Technical Service Bulletin: tsb100298

New Connecting Rod Bearings

The affected applications are all QSK45 and QSK60 engines made on or after June 30, 2003, with approximate engine serial number first 33154283.

Figure 1, Old Bearing Tang versus New Bearing Tang

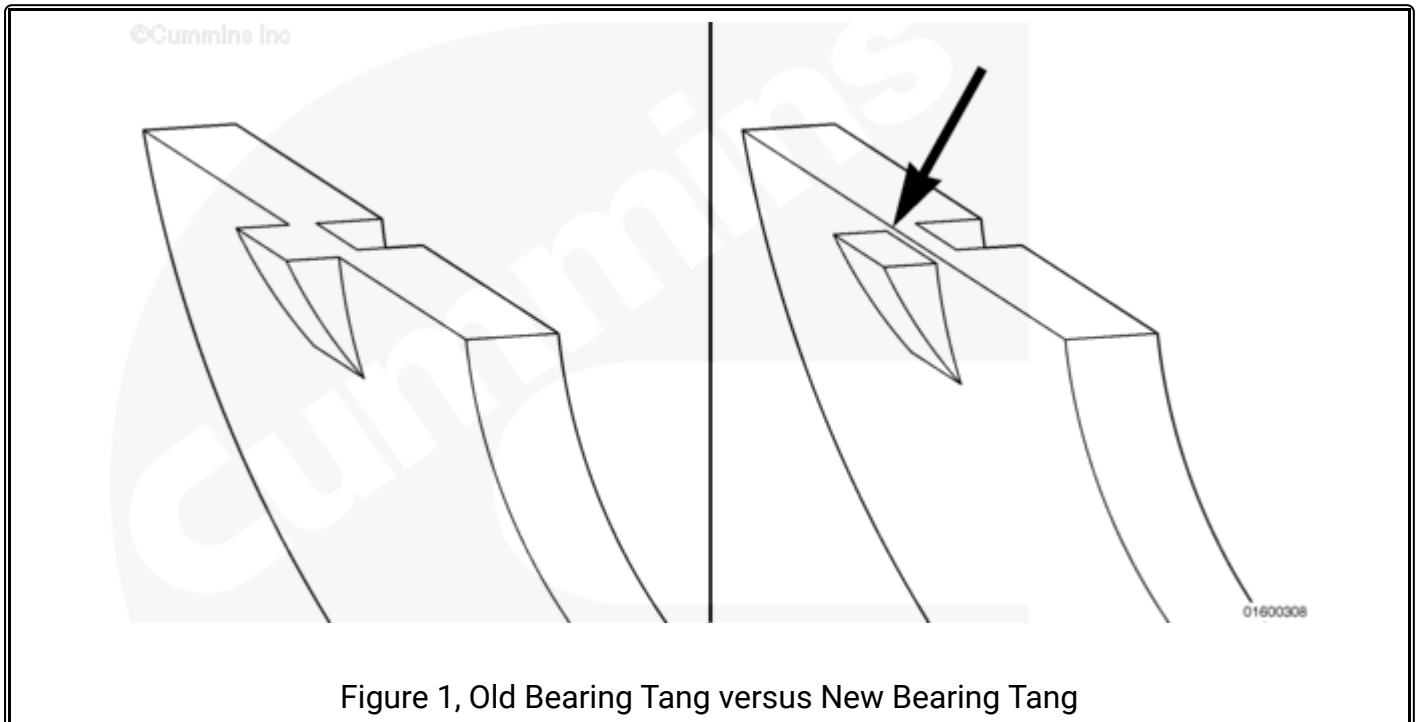
In order to increase the serration surface area on the new connecting rod, Part Number 3635125 and Part Number 3635126, the rod bearing tang had to be modified to eliminate the interference with the added serrated area. The new rod bearing features a 'drop notch' tang, that is cut slightly shorter than the edge of the bearing shell, in order to clear the serrations without interference.

The new connecting rod bearings are fully compatible with the new connecting rods, Part Number 3635125 and Part Number 3635126, and with the old connecting rods, Part Number 3171060 and Part Number 3171061. No stock of the old connecting rod bearing is left in factory production as of July, 2004. Please replace all entries of the old connecting rod bearing part numbers with the new part numbers on hard copies of the QSK45 and QSK60 Parts Catalogs, per the following table.
